**Before the Hearings Panel
At Wellington City Council**

In the matter of the Proposed Wellington City District Plan

**Hearing Stream 6 (Future Urban Zone, Lincolnshire Farm Development Area,
Upper Stebbings and Glenside West Development Area, Appendix 12, and
Appendix 13) Reporting Officer Right of Reply of
Hannah van Haren-Giles on behalf on Wellington City Council
Date: 2 April 2024**

Mr Halliday's supplementary evidence map and numbering key

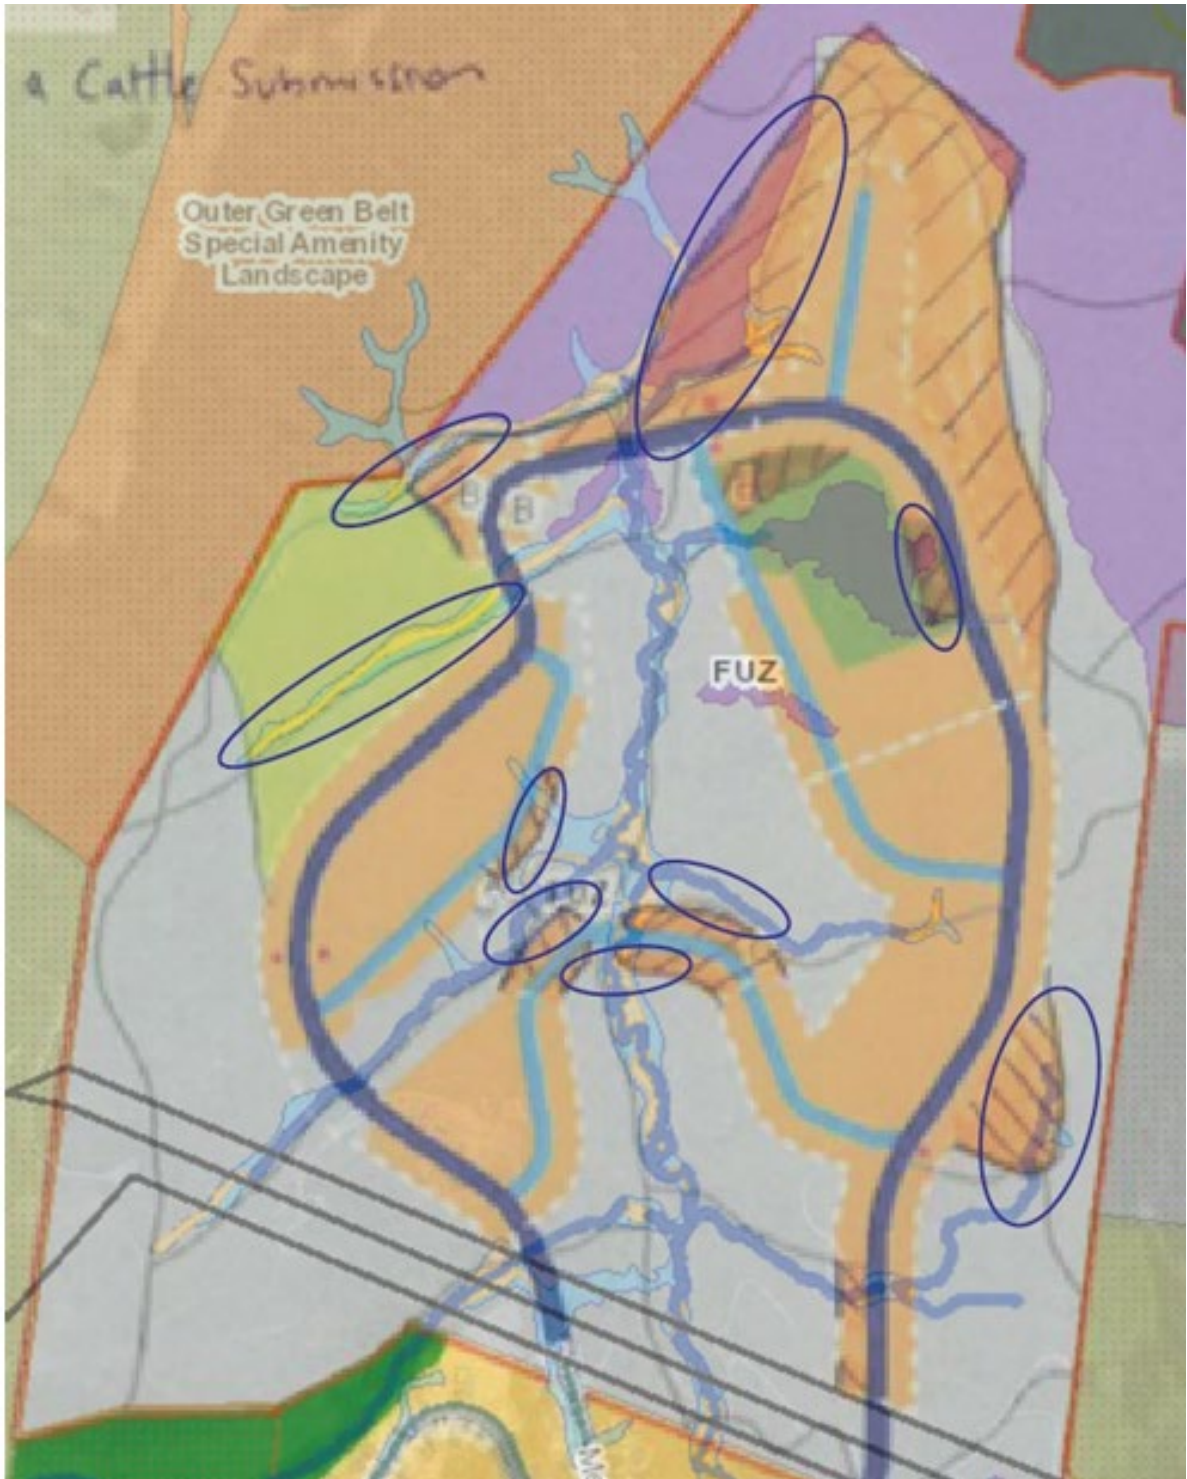
25. My revised assessment of Mr Halliday's requests for new MRZ areas in Upper Stebbings is set out below. This assessment is in response to Mr Halliday's [supplementary evidence](#).
26. I refer to Mr Halliday's map and numbering key below for reference. While I acknowledge Mr Halliday has provided detailed 'close ups' of each of these nine areas, I prefer the map contained in my s42A Report which shows the relevant overlays including SNAs, stream corridors, inundation areas, and overland flowpaths. In addition to these features I have also taken into consideration topography and the Ridgetop area.

Area 1 – Head of Upper Stebbings (North End)

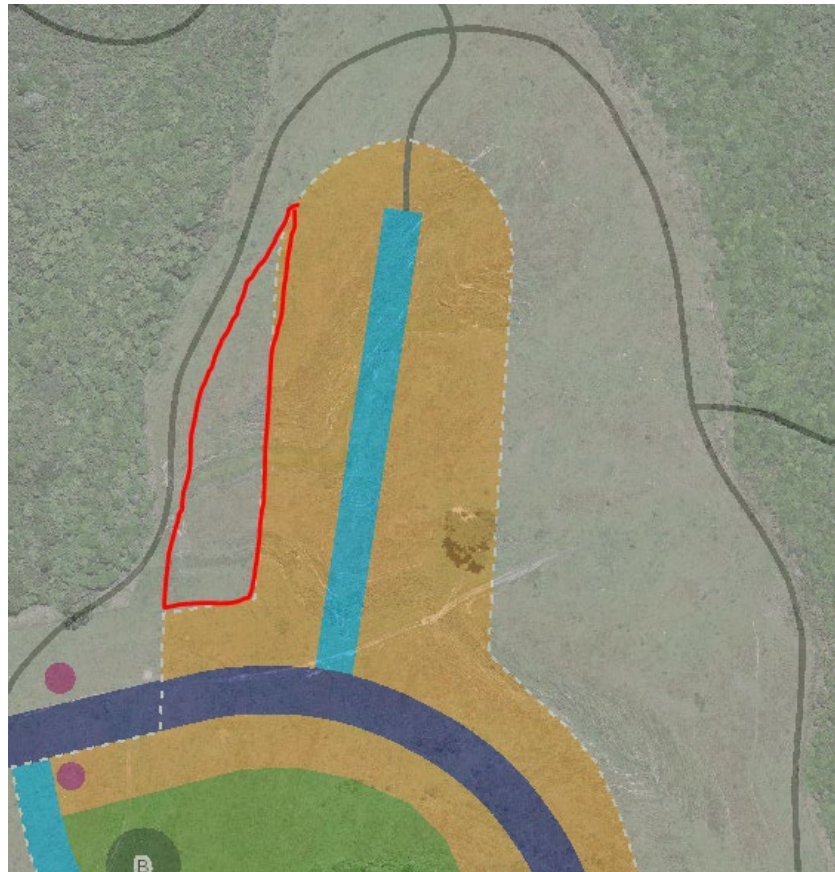
27. I agree in part with Mr Halliday that a small amendment in this location would be an appropriate MRZ extension, provided it does not affect nearby streams, SNAs, ridgetops and the other factors identified in paras 171 – 172 of my Section 42A report. The change will increase housing and subdivision design options while retaining the natural features and layout intended in the Development Area. Including indicative walking track.

Area 9 – North-west periphery

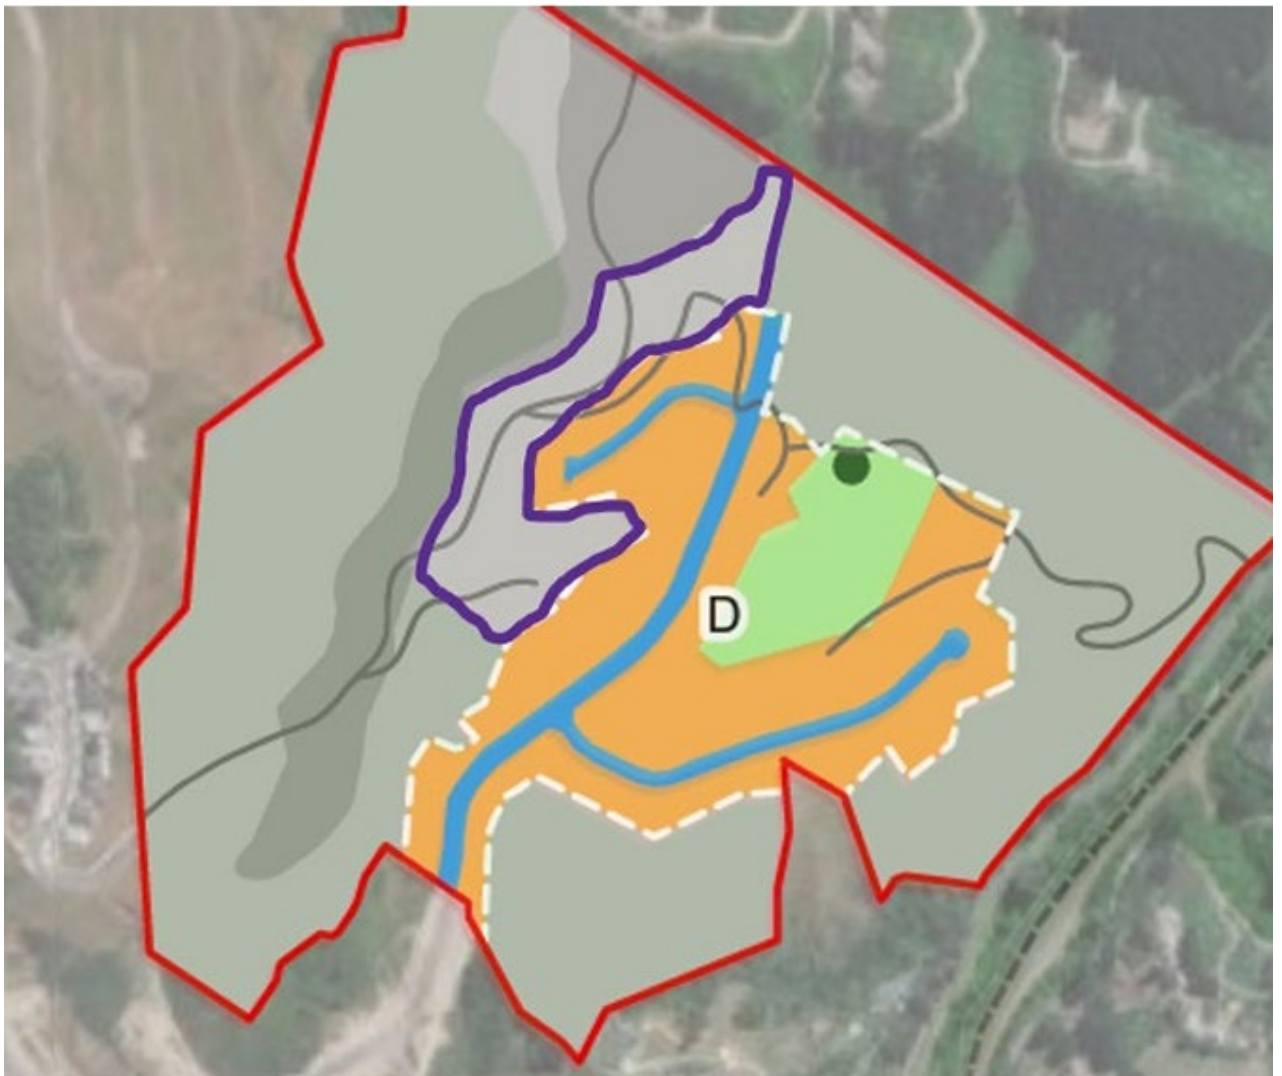
38. I disagree with Mr Halliday's proposal to extend the MRZ on this corner. The adjacent stream to the northwest of this area is an important part of the water catchment for the SNA on the other side of this area, and stream corridors are natural features that have been identified as needing to be retained in the Development Area.

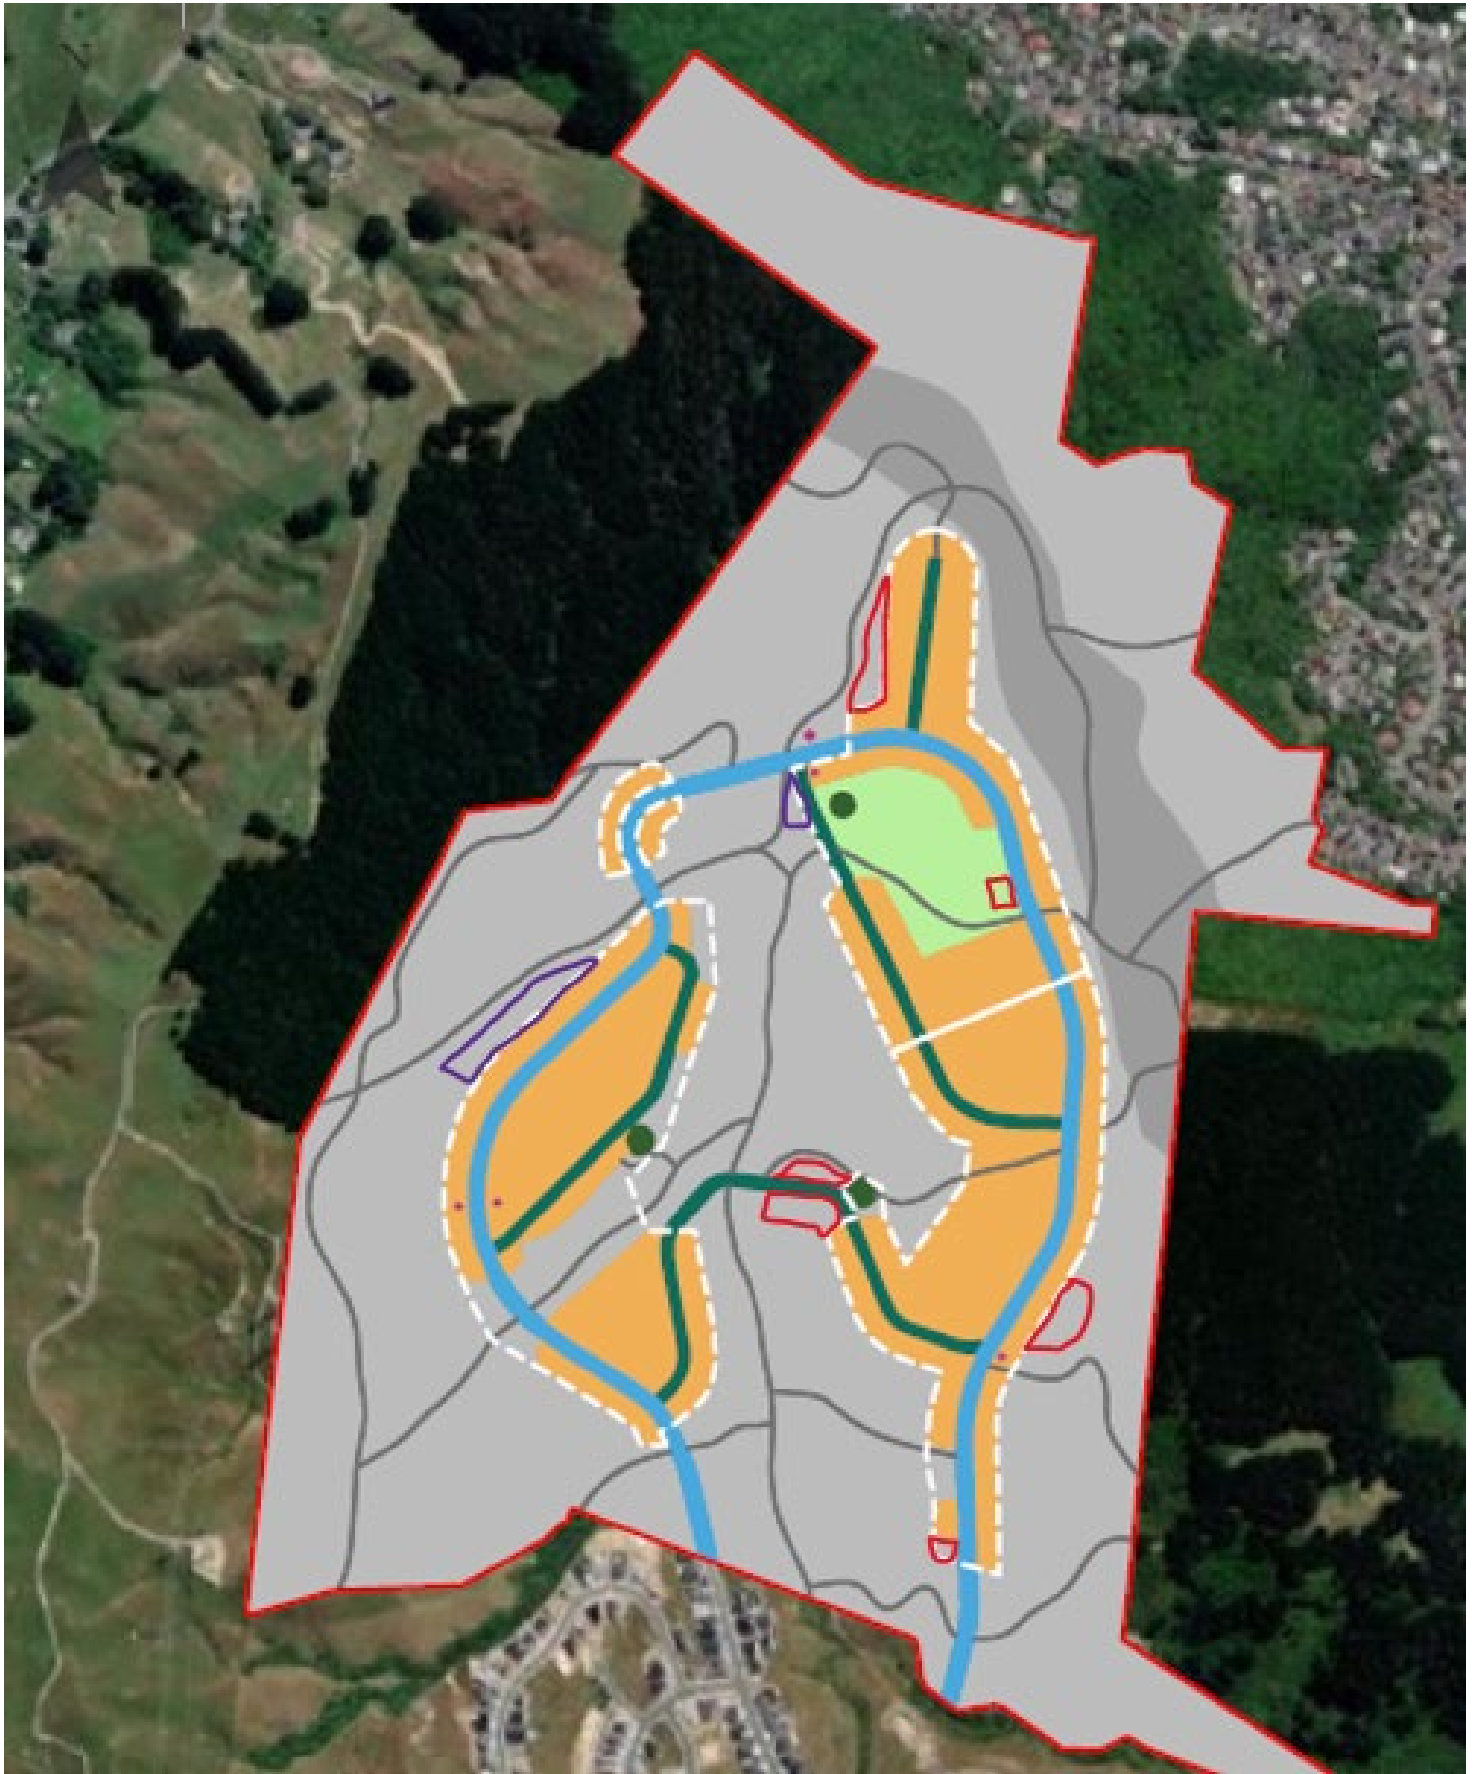
42. With respect to Upper Stebbings, no amendments to the Development Plan were recommended in my s42A Report in response to Mr Halliday's submission. In my supplementary evidence I recommended the addition of two medium density residential areas. Through this Right of Reply I recommend a further four amendments to add medium density residential areas. These six amendments are yet to be accurately mapped. The below map portrays these six total amendments (purple – amendments recommended in supplementary evidence, and red – amendments recommended in this Right of Reply). A final Development Plan capturing these six amendments will be prepared as soon as possible.
